Supporting Materials for comment #140

Comment #140

D2.1 Signaling cont.

Proposed changes

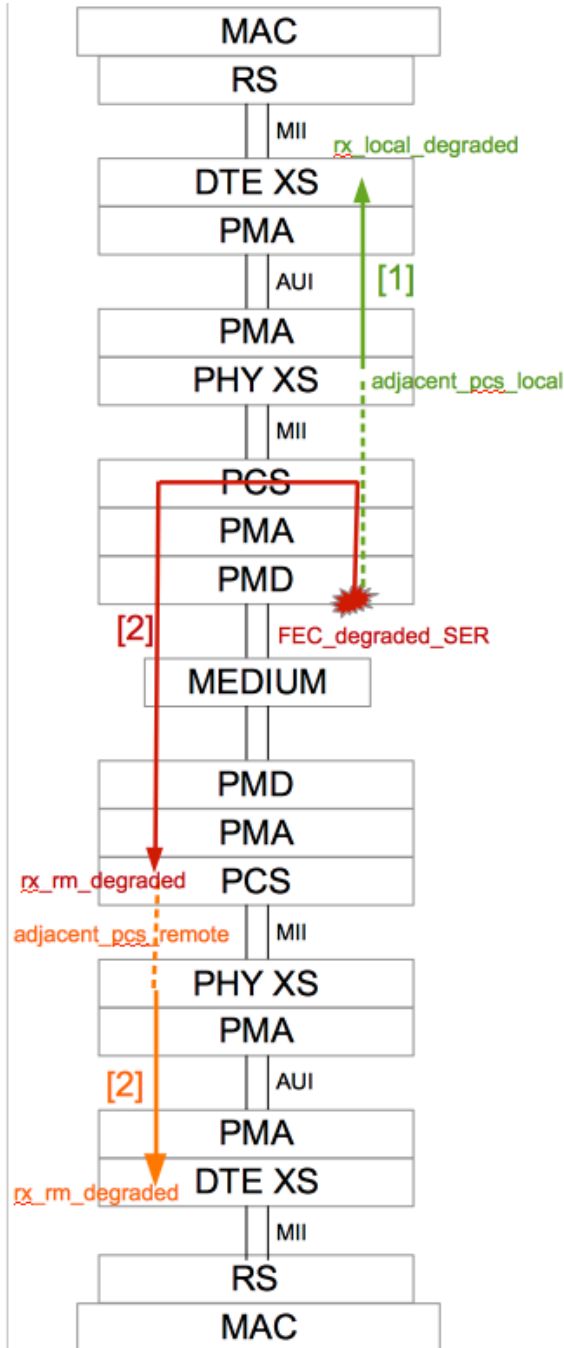
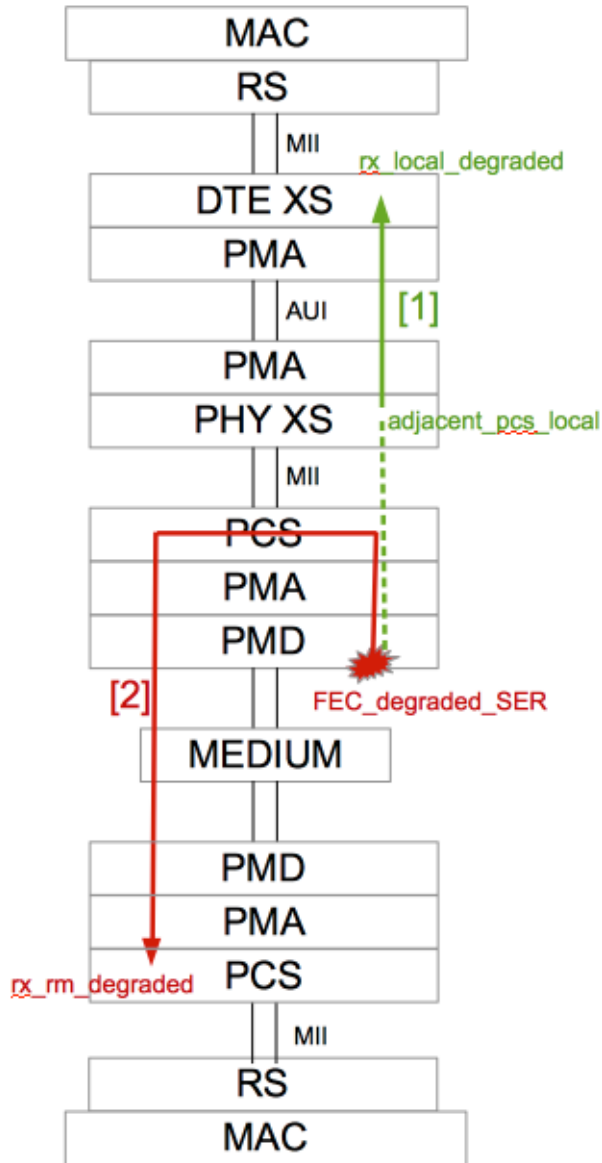
- The Clause 119 PCS does not forward a XS degraded signal. Clause 118 PHY XS also does not send a degrade indication across the AUI to the DTE XS.

Change:
Removed setting of tx_am_sf[2] by DTE XS when rx_am_sf[1] is received.

- **tx_am_sf<2:0>** = {FEC_degraded_SER + adjacent_degraded, 0, 0}
- Delete MDIO mapping in the definition of **rx_rm_degraded**, rely on Table 119-5 to map it
- Add **adjacent_degraded** variable
 - Boolean variable which is asserted when an adjacent XS layer (across the MII interface) has set either FEC_degraded_SER or rx_rm_degraded. When an XS layer is not adjacent to the PCS this variable is set to false.
- Alternate definition which is less restrictive on who the adjacent layer is
 - Boolean variable which is set to false when the MII interface is connected to the RS. Otherwise it set to true when either FEC_degraded_SER or rx_rm_degraded is set on the adjacent sub-layer (across the MII interface).

- Delete the change in behavior **tx_am_sf** (acts the same as Clause 119)
 - Leave **rx_local_degraded** as-is. But remove the requirement of **SER_enable**, monitoring and reporting of **rx_am_sf[1]** is always done.

- Change **tx_am_sf** to be:
 - **tx_am_sf<2:0>** = {adjacent_degraded, adjacent_pcs_degraded + FEC_degraded_SER, 0}
 - Delete “When **FEC_degraded_SER_enable** ...” sentence
 - Delete **rx_rm_degraded** definition and rely on PCS definition and Table 118-2 to map it to right MDIO variable.
 - Delete **adjacent_pcs_local_degraded** and **adjacent_pcs_rm_degraded**
 - Add **adjacent_degraded** variable
 - Boolean variable that is asserted when the adjacent PCS sublayer has it's **rx_rm_degraded** variable asserted.
 - Add **adjacent_pcs_degraded** variable
 - Boolean variable that is asserted true when the adjacent PCS sublayer has it's **FEC_degraded_SER** is asserted.
